IN THE DRAWINGS:

Applicant proposes to amend Figs. 9 and 11 of the patent application to harmonize with the description of the invention in the written Specification. To that end, a separate letter to the Chief Draftsperson is attached requesting that the Drawings be corrected.

FIG. 1

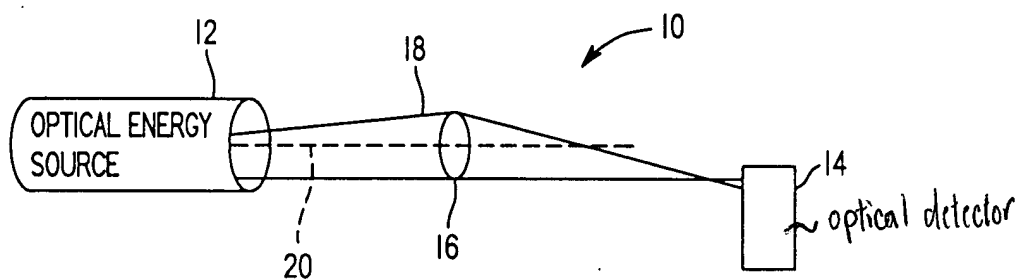
Fig. 1 has been amended to include a descriptive legend for element 14.

FIG. 9

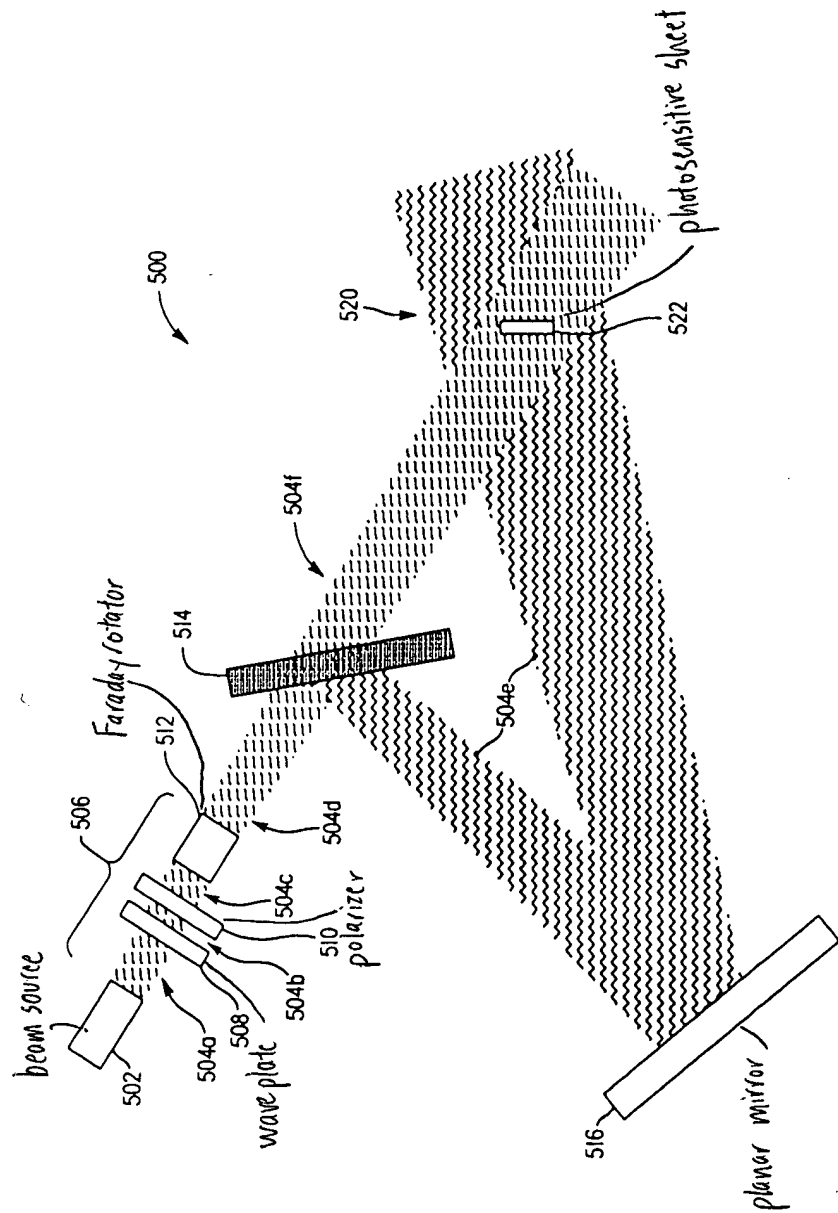
Fig. 9 has been amended to include a descriptive legend for elements 502, 508, 510, 512, 516, and 522.
